This is a section of the block plan, for planning application 2024-91236. It includes the bungalow (at 92), and the house planned for plot 23. The blue line has been added to show what should see looking down the side of the bungalow, from the back to the front. Note, all of the house at plot 23 is on the left-hand side of that blue line.

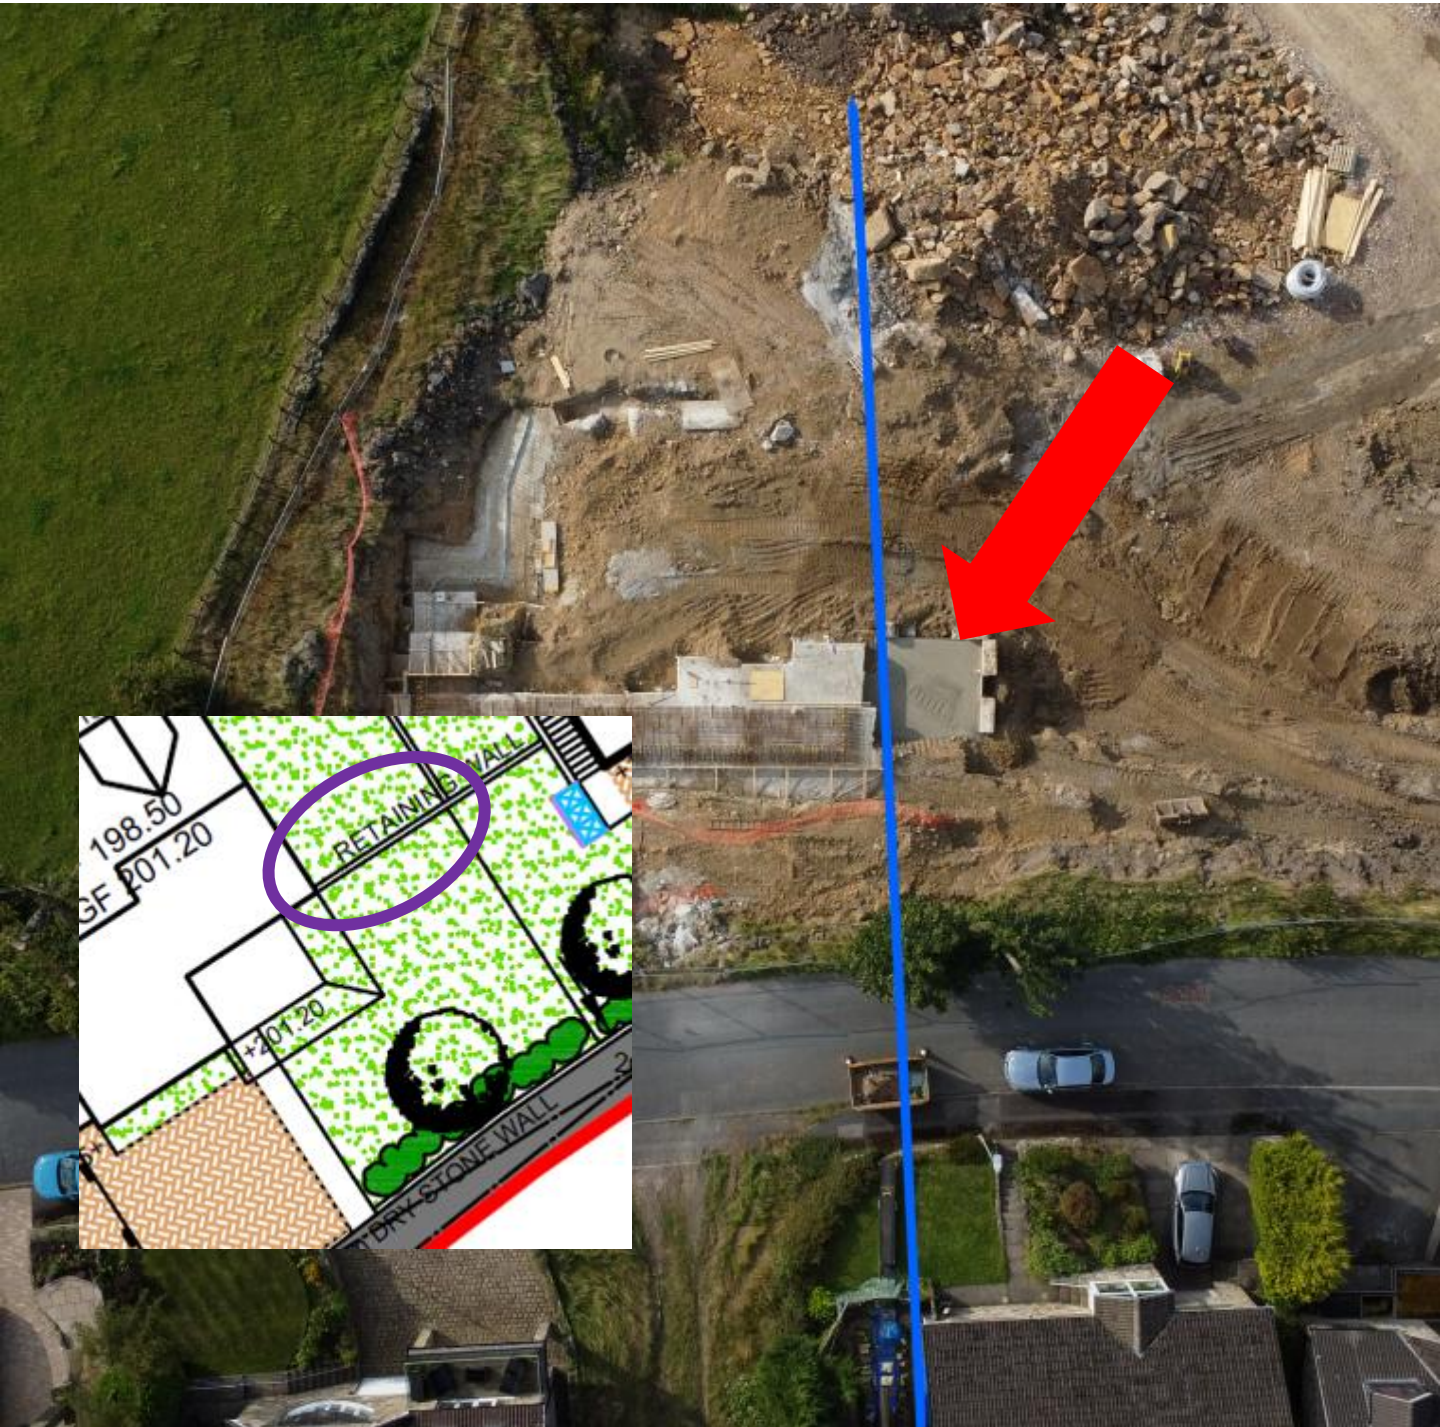
This is the actual gable end of the bungalow, looking back to front. It ought to follow the blue line from the previous page. If you look beyond the wheelbarrow, through the fence, you will see yellow caps, on top of the rebar, on the site opposite. That is the end point of the rebar, where it stops running parallel with the road, and heads in to the site.

The yellow arrow points to the same yellow caps seen on the previous page.

This is an aerial photo, taken yesterday, showing the same blue line as mentioned previous. I have added a yellow arrow that shows where the rebar ends, and turns in to the site. This is the same rebar seen on the previous page.

I previously thought the concrete pour, pointed to by the red arrow, was (an over engineered base) part of the retaining wall, shown in the inset picture (identified by the purple ellipse).

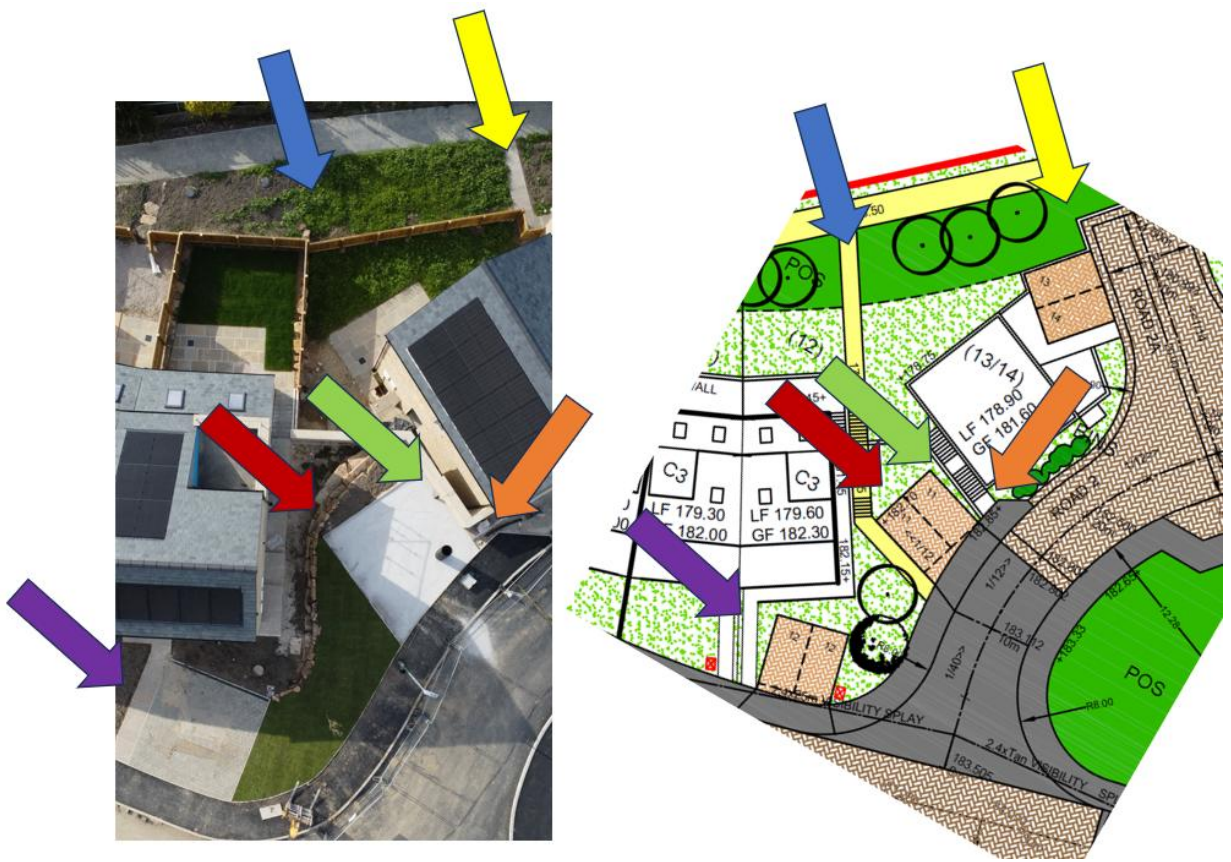
I then thought maybe the concrete pour was part of the stairs that go between the lower ground floor, and the ground floor. The concrete pour being the lower ground floor level (cyan arrow), with the first floor to be built up, on top of the concrete pour where the rebar is (green arrow).

If the concrete pour (blue arrow) is for the stairs, then it should be where the green arrow is.

That would mean the house is being built in the wrong place (because it is to the right of the blue line), or it is being built bigger than it should be.

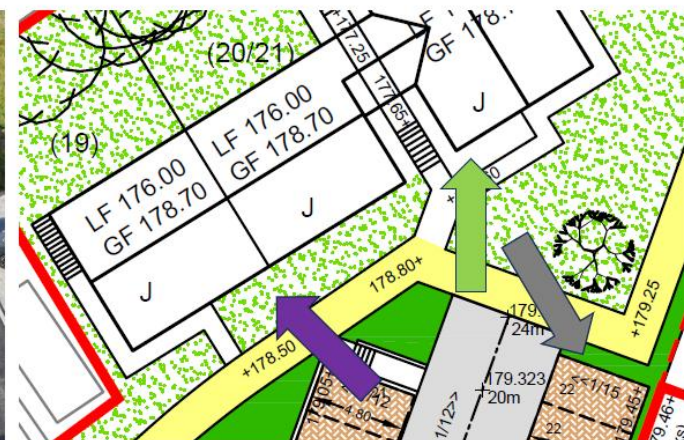
There are other examples of plan variations, occurring on this site, that support unapproved changes...

-  Paving misaligned, and landscaping missing
-  Path missing
-  Path added
-  Large stone wall added
-  Area of landscaping missing
-  Steps from lower floor to roadside pavement missing
